WINCHESTER SOUTH PROJECT  
WATER AND FINAL LANDFORM ADDENDUM

JUNE 2023  
Project No. WHC-18-62  
Document No. 01185344-006.docx

Figure 3-1D

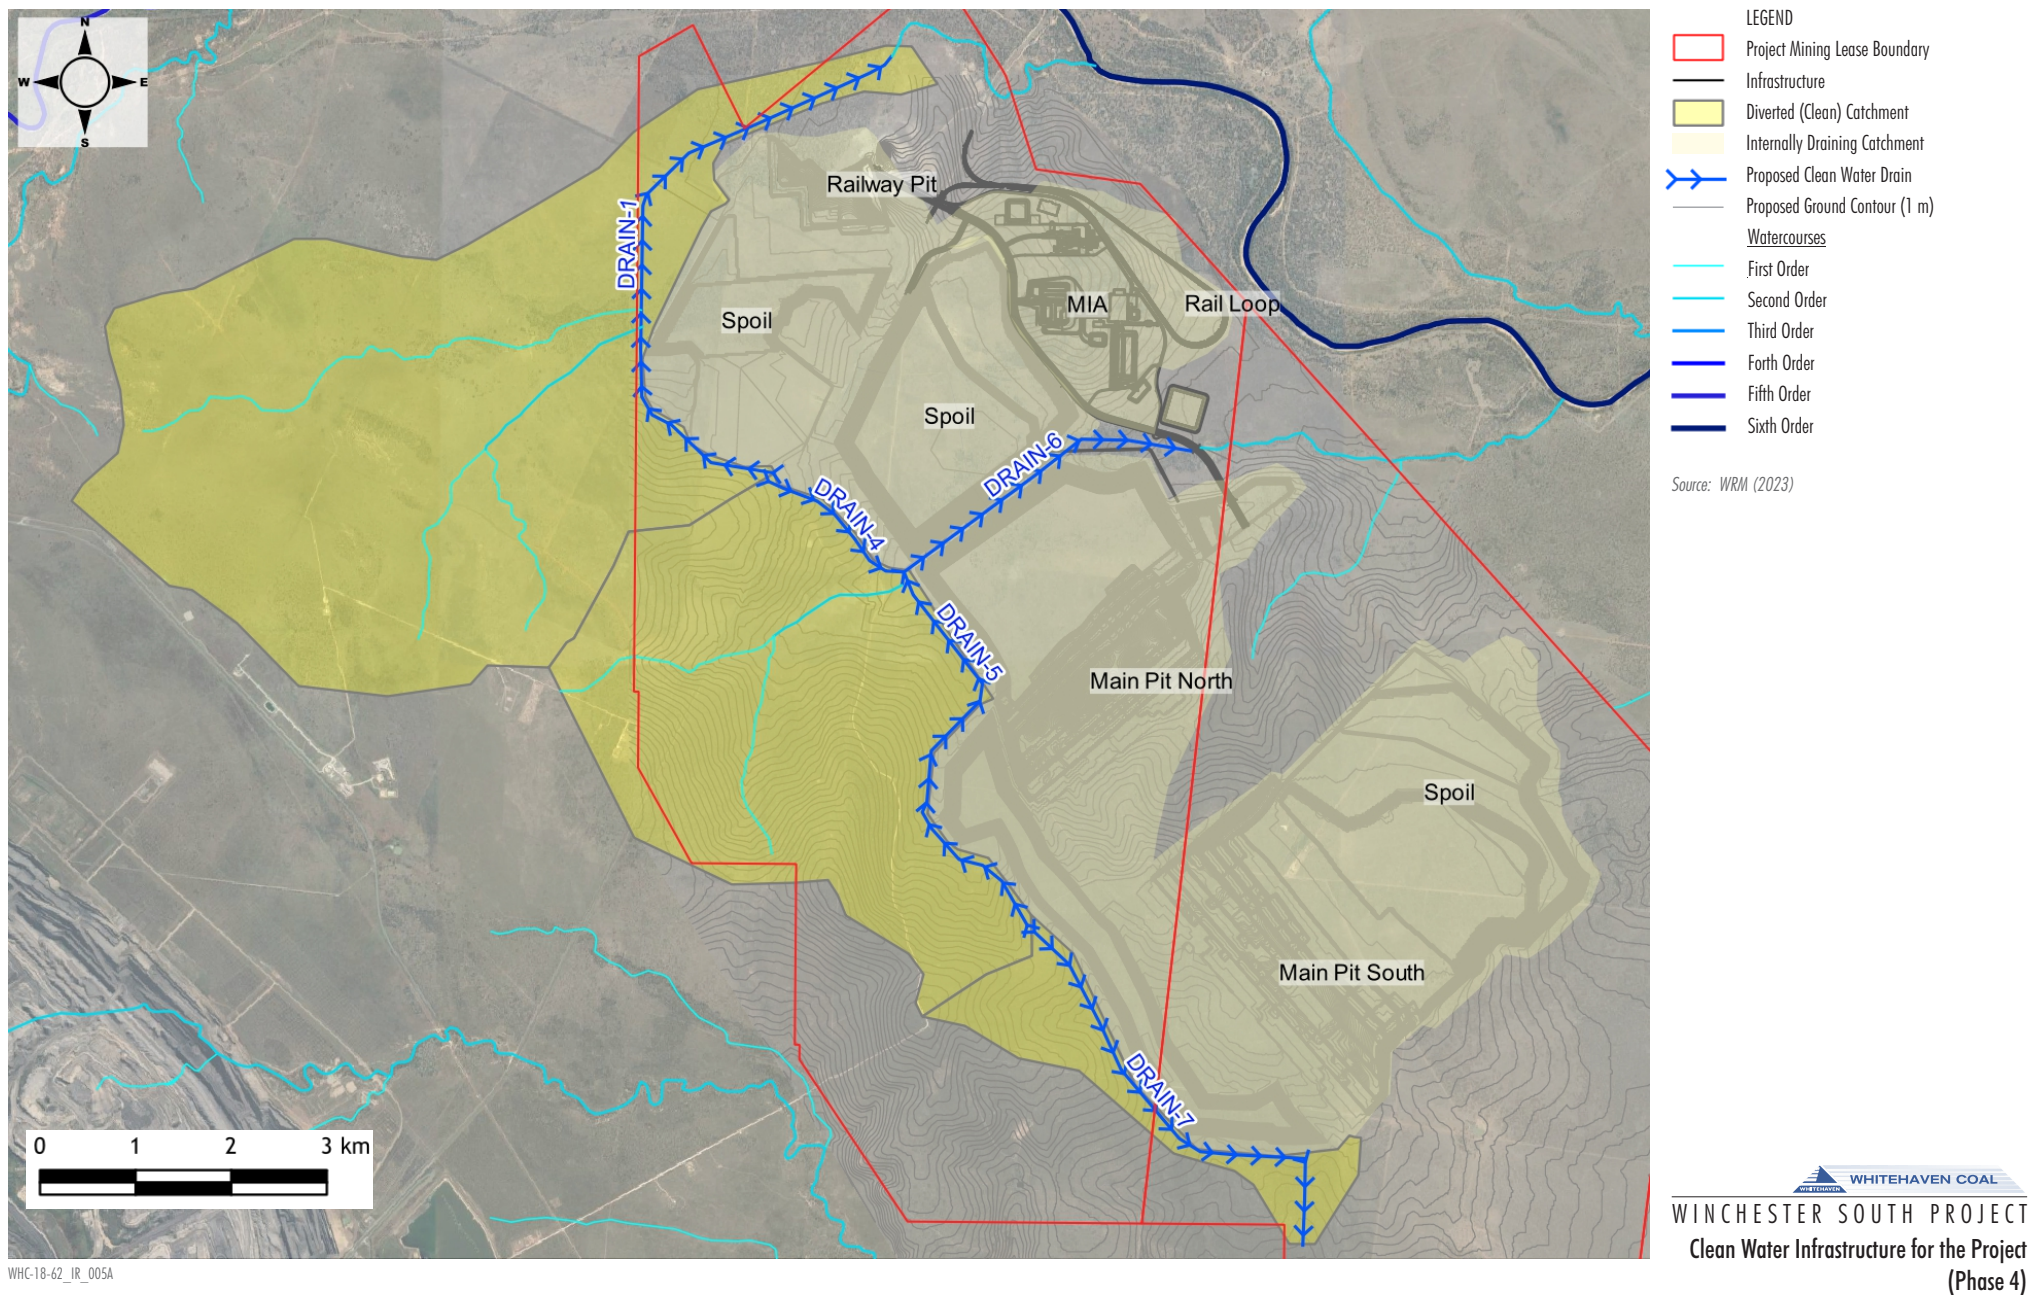
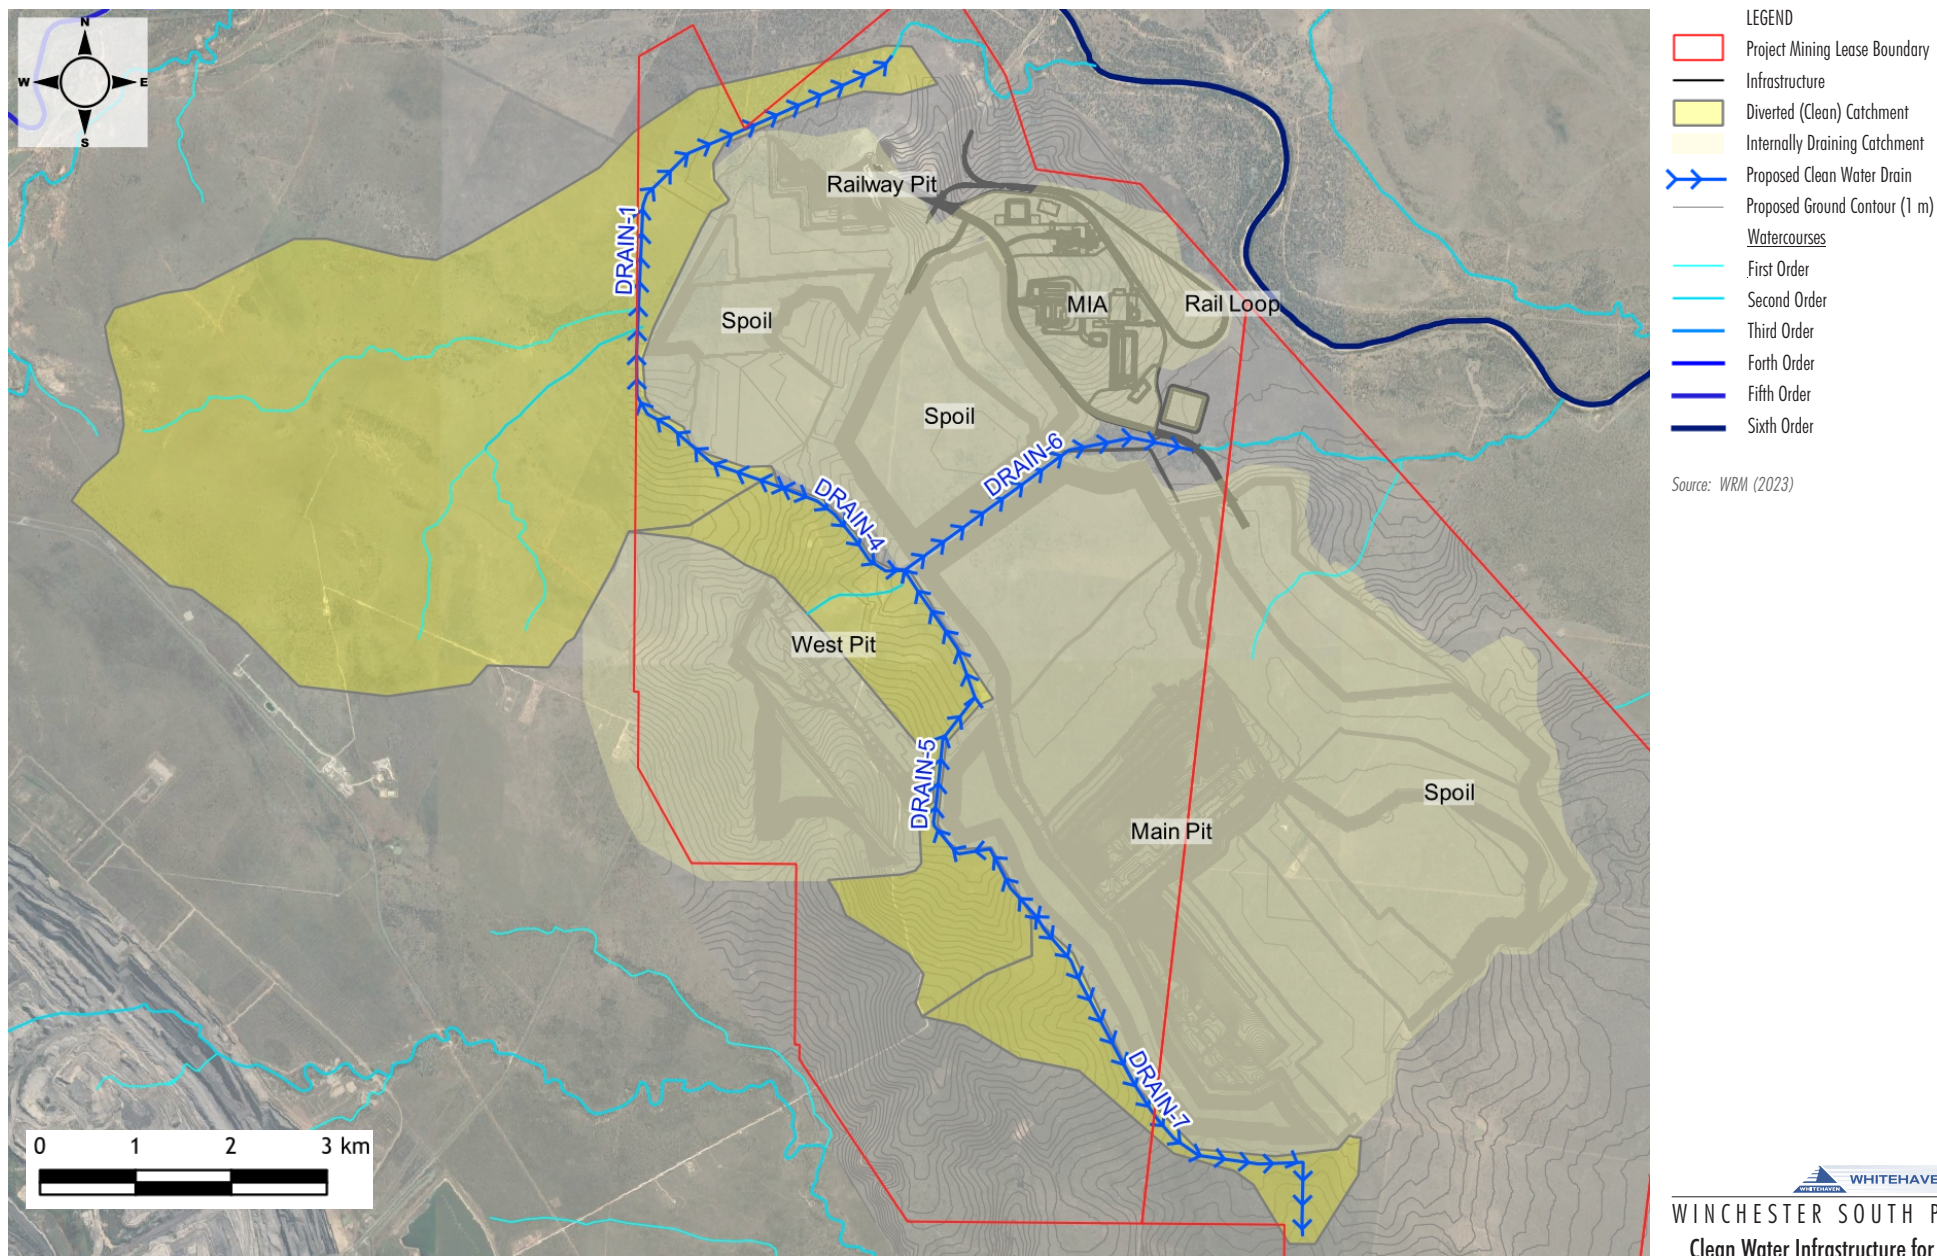
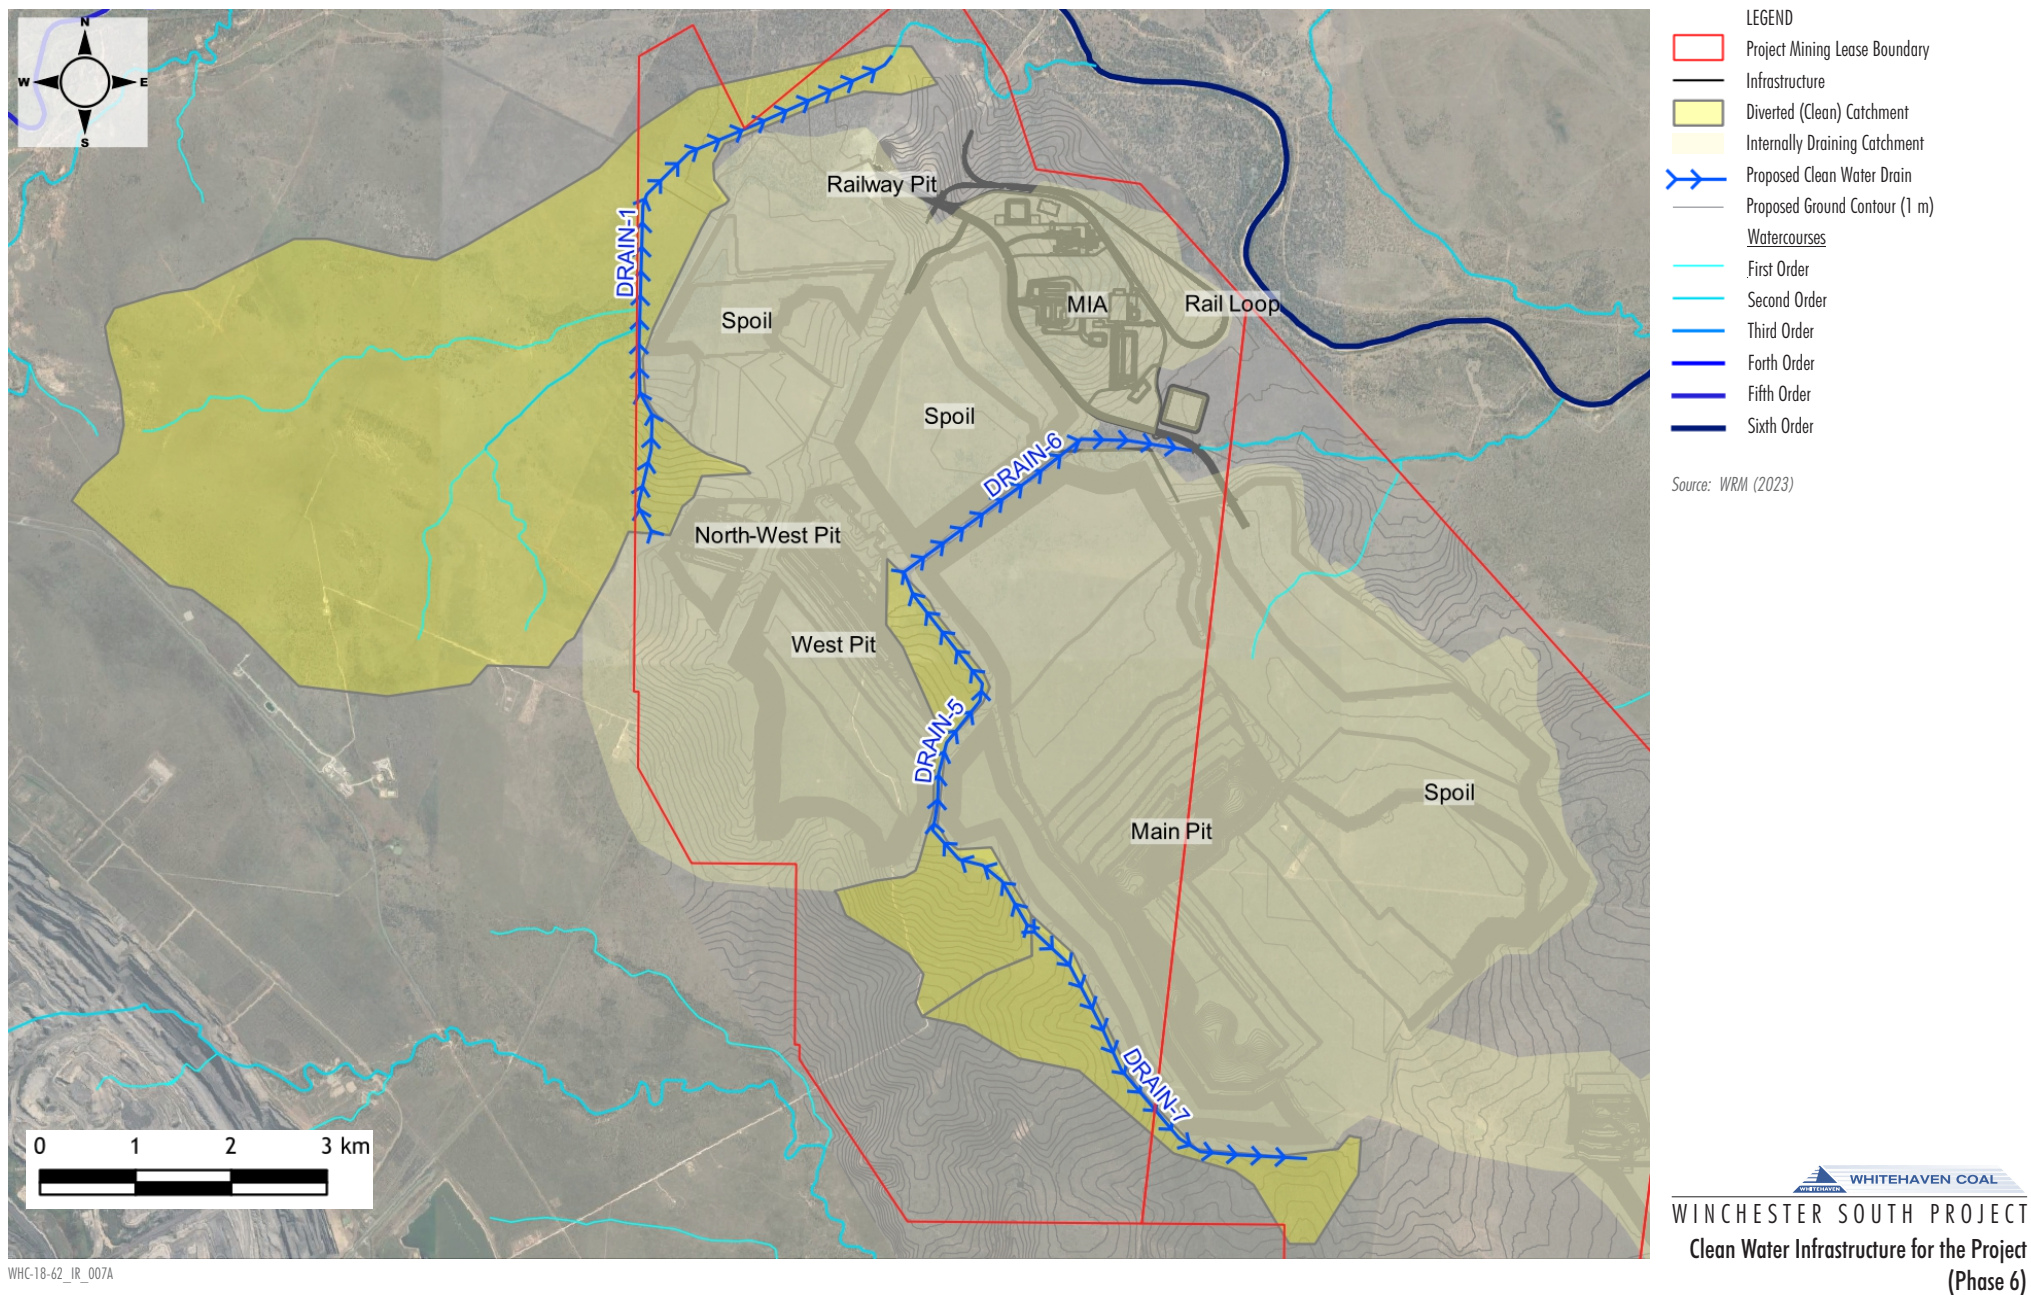
Section 2.7 (water management) of the project description lists CWD 1 and 2 as proposed water storages, and shows CWD 1 on Figure 2-5.

Clean Water Dams (CWD) 1 and 2 are shown in the DEIS SWFA on figures 5.3, 5.4 (proposed water management system) and Figure 6.2 (water management system schematic), and Table 6.5 where CWD 1 has a design storage volume (DSV) of 26ML and a total storage volume (TSV) of 523ML, and CWD 2 has a DSV of 56ML and TSV of 1,121ML. CWD 1 and 2 will impound flows related to the unnamed central waterway.

The size and operation of the clean water dams was raised in a submission on the DEIS from DRDMW (DEIS issue 452.03). The submission noted that the dams proposed to capture overland flow had a maximum capacity greater than 50ML, and under section 110, 2(b) of the Water Plan (Fitzroy Basin) 2011 would require a water licence under the Water Act 2000.

Section 5.6.1 of RDEIS Attachment 6 (SWFA) has removed reference to CWD 1 and 2 in text and figures and now states: Whitehaven WS may implement alternative clean water diversions over the life of the Project to divert water around active operations. This could potentially include diversions/embankments that are located further upslope than the indicative locations shown on Figure 5.1 to Figure 5.6 (within the proposed Project footprint) and/or clean water dams and associated pumping infrastructure.

In response to DES issue 584.32 on the RDEIS, the following direction to the proponent was given: Provide a detailed description of the design and location of clean water management system (including waterway diversions) to ensure all relevant potential impacts are identified and adequately assessed.

Whitehaven's response to this issue referred to four dams in the MIA (in the context of another section of the direction to proponent around MAW storage capacities) and conditions F29 and F30 which relate to the water management plan. No further details of the clean water management systems are provided.

In response to DES issue 584.83 the following direction to the proponent was given: Provide a revised list of draft EA conditions and the required management approach that includes details of temporary and permanent disturbance of water flow paths/patterns, including levees, regulated structures and other water management infrastructures such as diversions. Provide maps at suitable scale for all locations.

A series of up-catchment clean water drains are proposed to temporarily divert clean runoff water around the active mining areas. The indicative locations of the clean water drains for the various phases of the Project are shown on Figure 3-1A to Figure 3-1F. Diverting clean water around the mining areas has multiple benefits to operations and the receiving environment (compared with capturing all up-catchment runoff), namely:

Alternative clean water management strategies and infrastructure may be implemented over the life of the Project to divert water around active operations. This could potentially include development of additional drains/embankments as required. Detailed design of water management infrastructure would be outlined in the Water Management Plan for the Project and updated over the life of the Project. As described above, the indicative locations of clean water drains are shown in Figure 3-1A to Figure 3-1F. The drainage pathways for the rehabilitated final landform are shown on Figure 3-1G.

- Project Year 1 to Project Year 6 (Phase 1) operations shown in Figure 3-1A:
  - A clean water drain (DRAIN-1) diverts clean runoff around the south and west of the Railway Pit.
  - A clean water drain (DRAIN-2) diverts clean runoff around the east of the Railway Pit mining area.
  - A clean water drain (DRAIN-3) diverts clean runoff around the south of the Mine Infrastructure Area.
- Project Year 7 to Project Year 11 (Phase 2) operations shown in Figure 3-1B:
  - DRAIN-1 remains, diverting clean runoff around the south and west of the Railway Pit.
  - DRAIN-2 is removed as part of mining activities.
  - A clean water drain (DRAIN-4) diverts clean runoff around the south and east of the Main Pit North.
  - DRAIN-3 is removed as part of mining activities.
  - A clean water dam (CWD1/CWD2) (if required) temporarily holds clean runoff diverted via DRAIN-4.

- Project Year 12 to Project Year 16 (Phase 3) operations shown in Figure 3-1C:
  - DRAIN-1 remains, diverting clean runoff around the south and west of the Railway Pit.

- CWD1/CWD2 (if required) is removed as part of mining activities.
- Project Year 17 to Project Year 21 (Phase 4) operations shown in Figure 3-1D:
  - DRAIN-1 remains, diverting clean runoff around the south and west of the Railway Pit.

- A clean water (DRAIN-7) diverts clean runoff around the south of the out-of-pit emplacement, draining south towards a tributary of Ripstone Creek.
- Project Year 22 Project Year 26 (Phase 5) operations shown in Figure 3-1E:

- DRAIN-7 remains, draining south towards a tributary of Ripstone Creek.
- Project Year 27 to Project Year 29 (Phase 6) operations shown in Figure 3-1F:
